Northern Quartz Campus

Surface water assessment - BESS, Substation and Transmission line

E231133 RP1

ES3 Request for information response

Figure 5.7 Water level longitudinal section – Section F-F

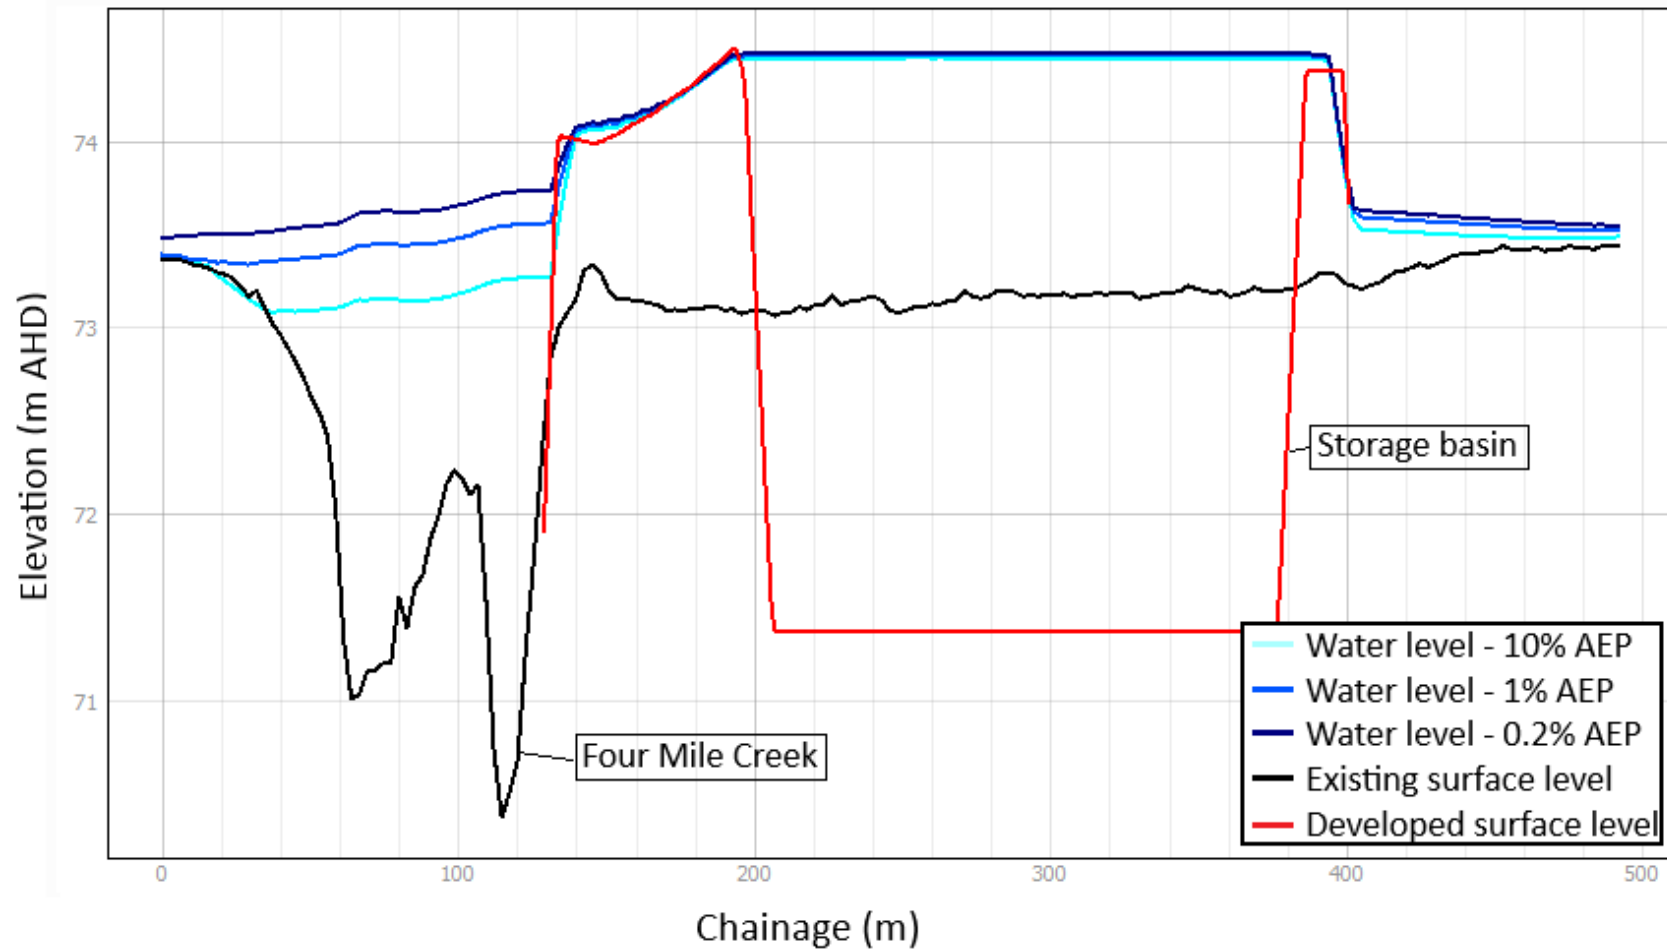
Detail	Response	Additional information reference
Sections are requested to be added to Figure 5.1. The submitted version shows blank plots.	Updated cross sections detailing the flood elevation levels against the existing and developed surface levels are provided in Section 5.4.1. The substation pad and BESS pad require elevation to meet their respective flood immunity requirements of 0.5% AEP and 0.2% AEP flood levels respectively. Figures 5.1 – 5.7 provide cross section elevations to show the flood immunity the development. These figures confirm the appropriate flood immunity of both the Substation Pad and the BESS Pad structures.	Refer Section 5.4.1
Flood report		
Peak water surface elevation plots are requested to be included in Appendix A, along with spot 1% AEP levels reported at key locations within and around the development.	Updated cross sections detailing the flood elevation levels against the existing and developed surface levels are provided in Section 5.4.1 of the Water Resources Assessment Report. Additional plots on the 1% AEP levels at key locations within and around the development have been provided within Section 5.4.2 of the Water Resources Assessment Report. This information is further analysed and presented in Attachment A Flood impact assessment.	Water Resources Assessment Report Section 5.4.2, and Attachment A Flood impact assessment report.

The development lies within the TCC 'medium flood hazard' area. The substation pad and BESS pad require elevation to meet their respective flood immunity requirements of 0.5% AEP and 0.2% AEP flood levels respectively. Figures Figure 5.1 – Figure 5.7 provide cross section elevations to show the flood immunity of each pad.

Flood level long section figures show design flood level matching the top of design structures. This is due to the rain-on-grid flood modelling approach. As such, flood immunity is indicated by flood levels adjacent to the structures rather than directly on top of them. On pad pit and pipe drainage has been proposed on these structures, as well as top of pad gradient to perimeter drainage features to manage surface catchment, this is subject to detailed design phase.

Figure 5.8 Spot water levels – 1% AEP – Proposed scenario

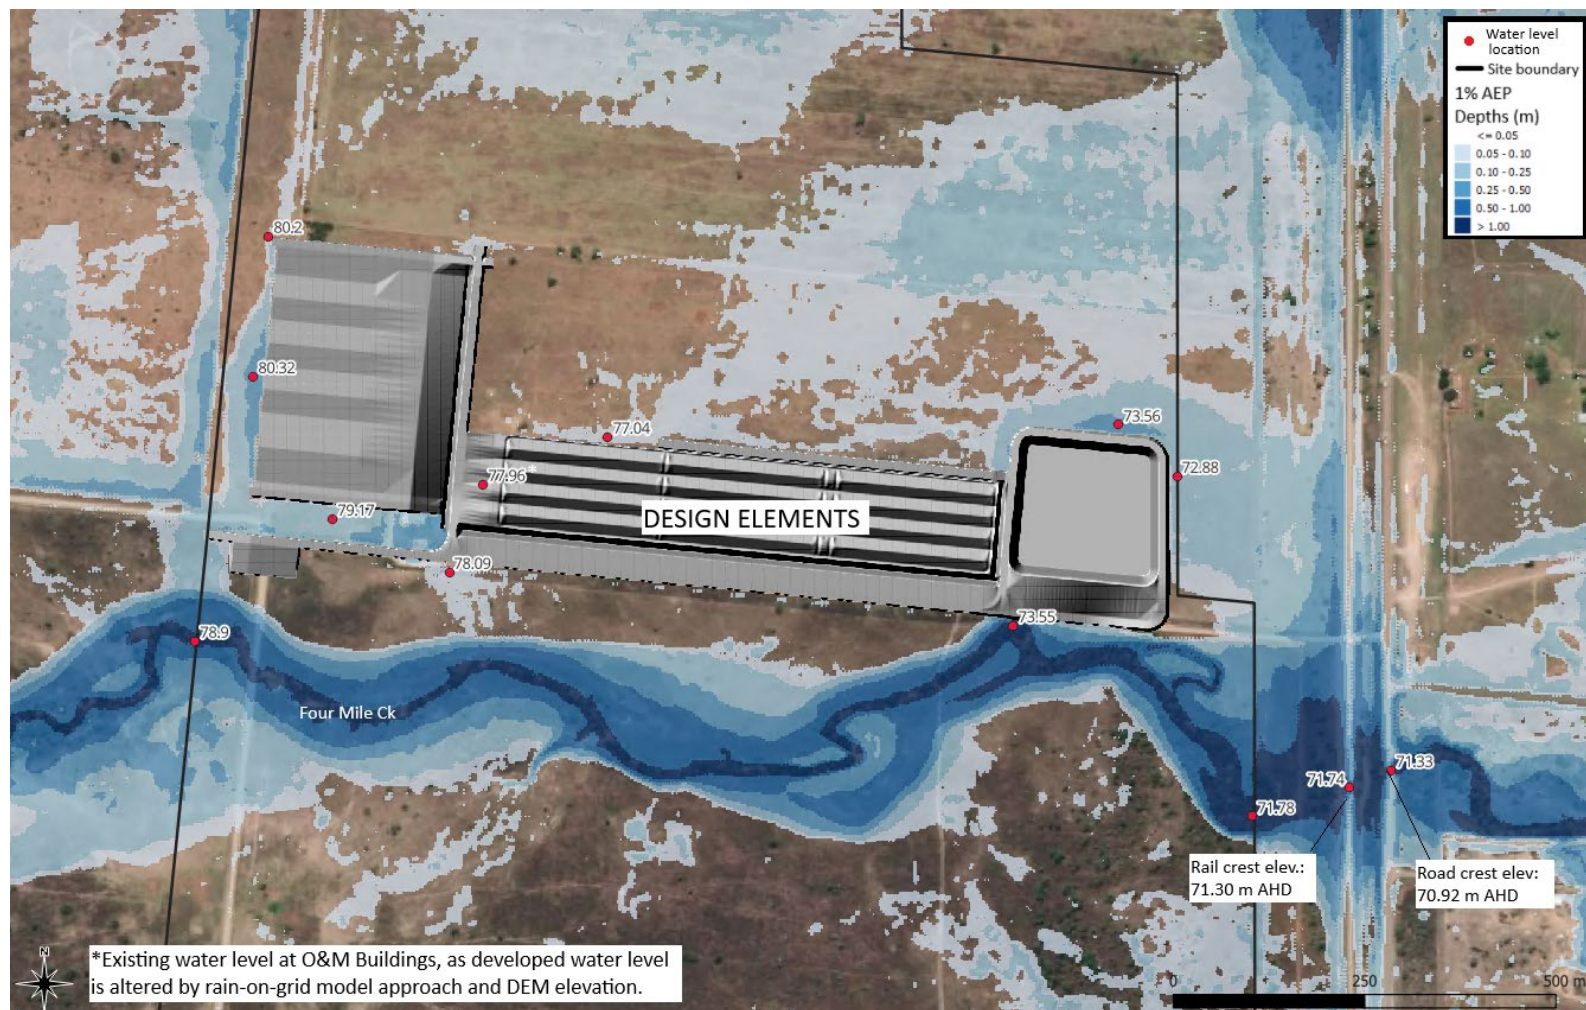
Flood report		
Peak water surface elevation plots are requested to be included in Appendix A, along with spot 1% AEP levels reported at key locations within and around the development.	Peak water level plots for the 10%, 1% and 0.2% AEP events (both existing and proposed scenarios) provided in Attachment A (Figures A2.1-A2.8), showing both ground surface and water surface elevations. Note: water level plots for developed scenario follow contours of design structures due to rain-on-grid results outputs. Plots show design water levels in surrounding water courses and surrounding design infrastructure. Spot water levels (1% AEP) are also provided in Attachment A.	Further discussion provided in Section 4.2. Figures updated in Attachment A.
The scale of the peak depth and velocity plots contained in Appendix A is requested to be modified (zoomed-in) to show enhanced detail within the development site.	Updated scale to zoom closer to site to provide more detail of results.	Further discussion provided in Section 4.2. Figures updated in Attachment A.

With the exception of the O&M Control Room, all infrastructure will be constructed atop the pad, which has 1% AEP flood immunity. The O&M Control Room will not be atop the pad, however will be constructed above the 1% AEP level with 500 mm freeboard. The 1% AEP water level at this location is 77.96 metres Australian Height Datum (m AHD) (as shown in Figure 5.8), therefore the design level for the O&M Control Room is 78.46 m AHD. This level will be attained during detailed design via a localised pad and/or piers to elevate the structure above the design floor level.

Northern Quartz Campus
Package 1
BESS, transmission line and substation
Flood Impact Statement
Figure A1.13

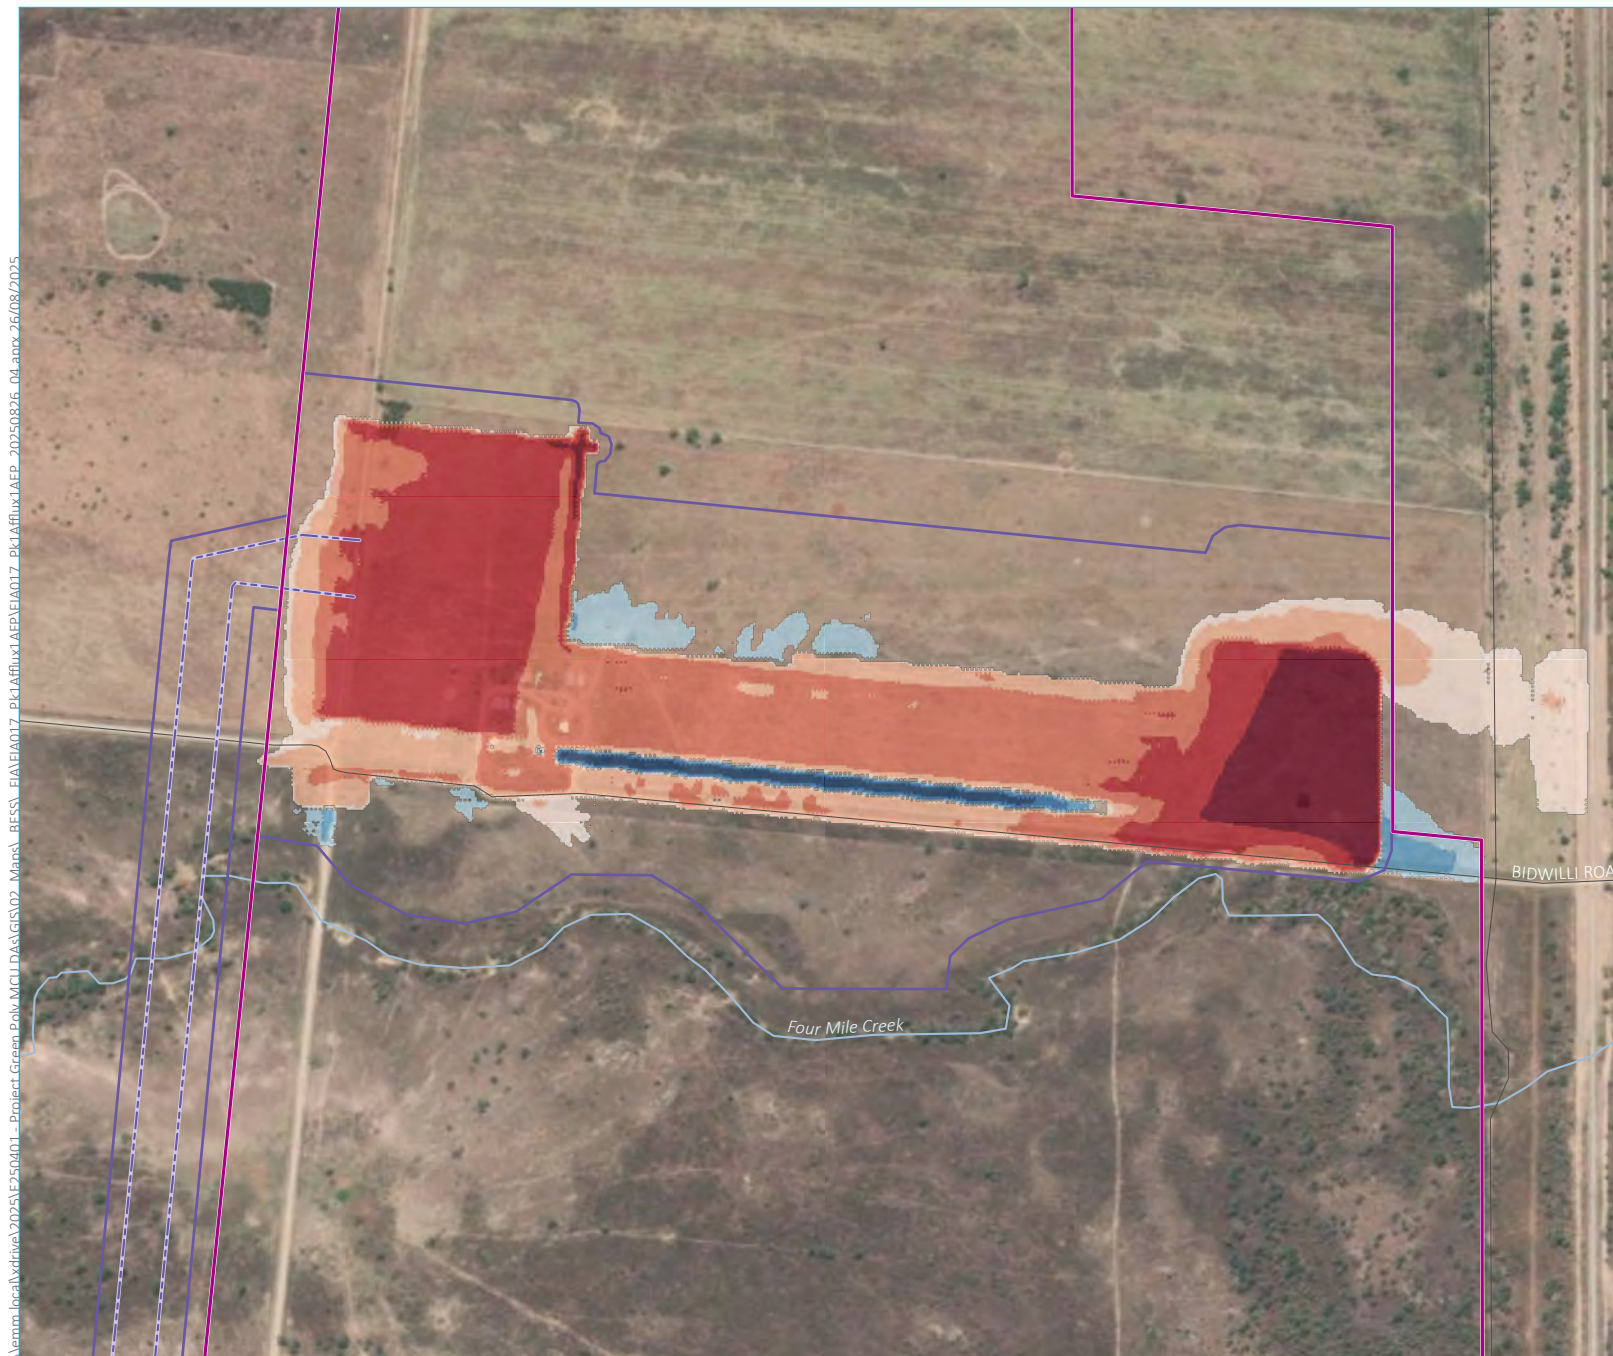
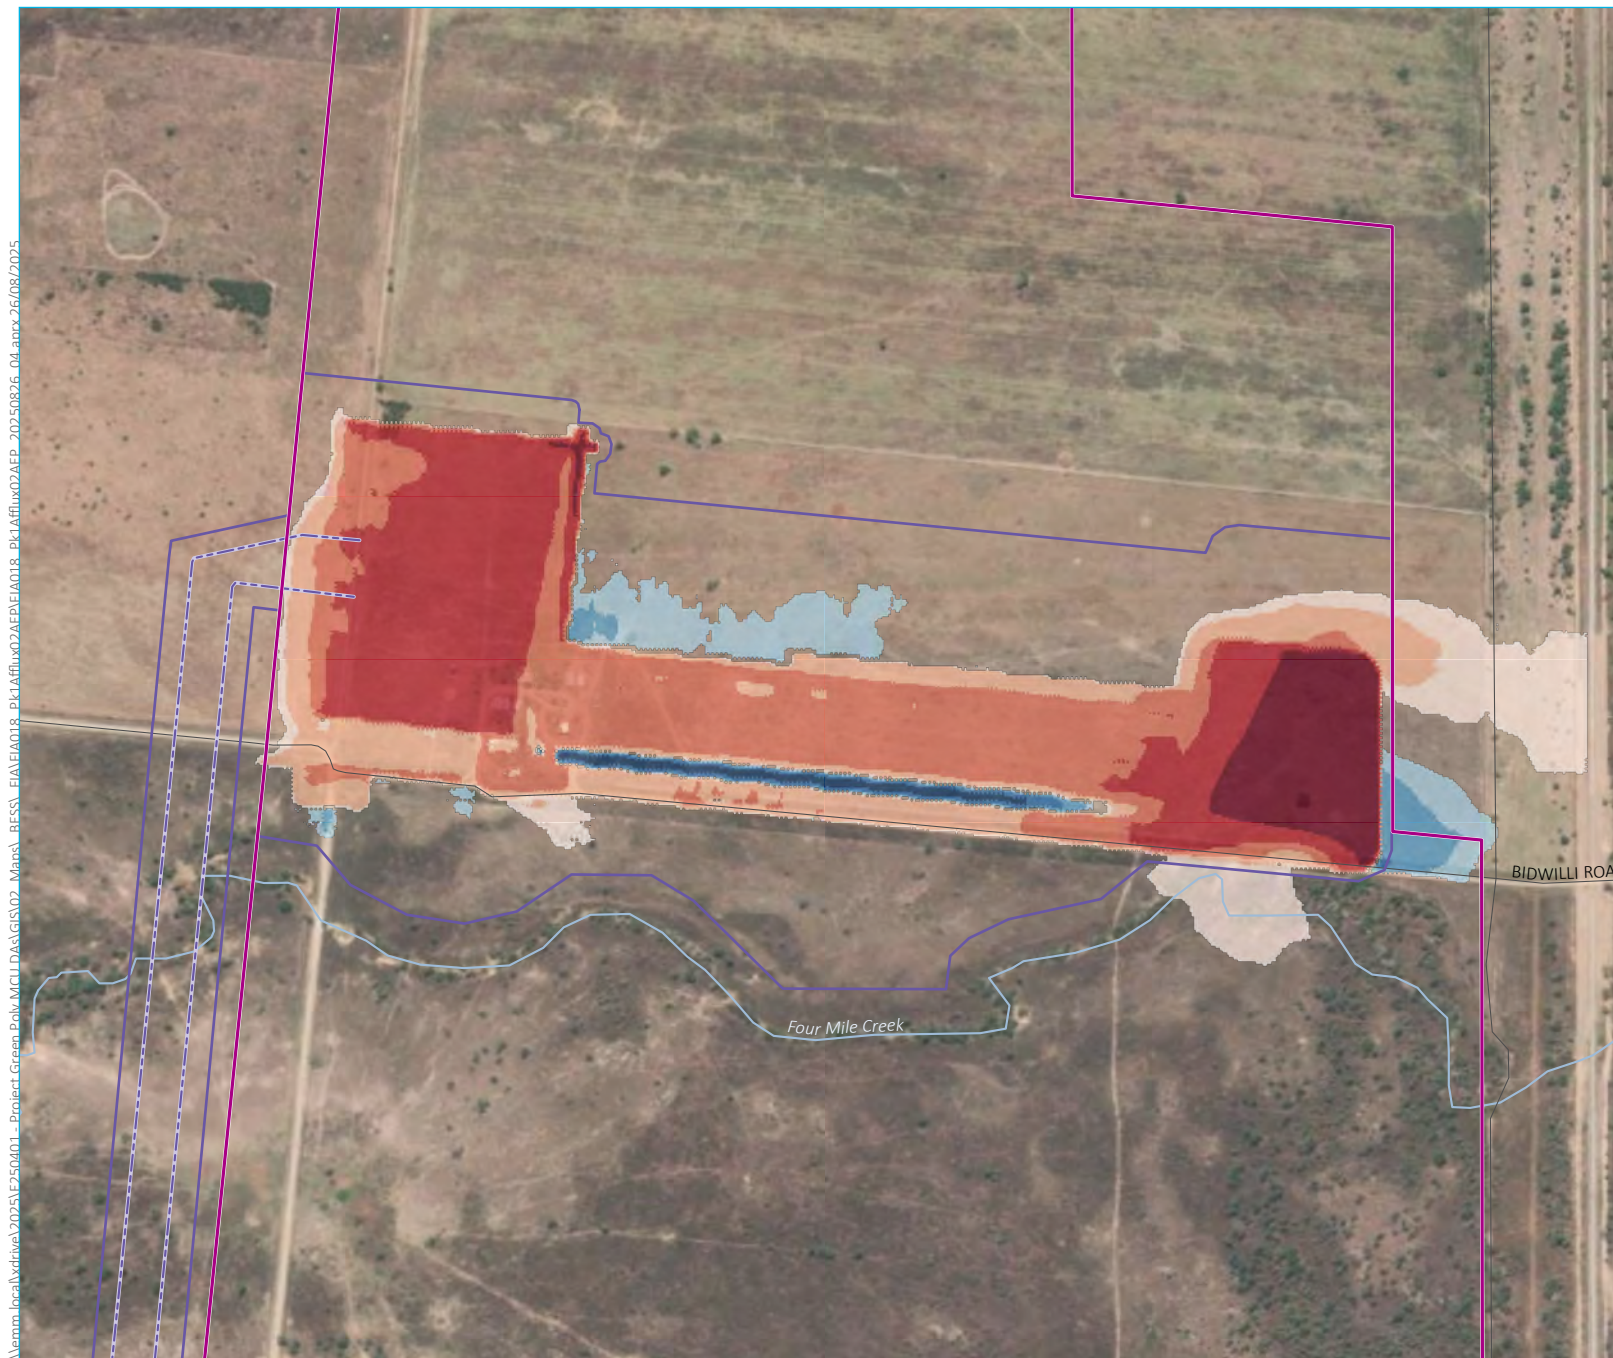
The 10% and 1% AEP afflux plots show 50-100mm of afflux within the State controlled road corridor to the east of the development site. The applicant is requested to confirm State acceptance of these impacts.	Current concept design demonstrates impacts within road corridor. However, these impacts will be mitigated during detailed design to achieve zero impacts to the road corridor. This will include design updates to water storage basin, drainage design, water treatment train and pad footprint/elevations to achieve this. Flood modelling of the detailed design will be performed to quantify and confirm these outcomes.	Refer Appendix A Section 4.2.
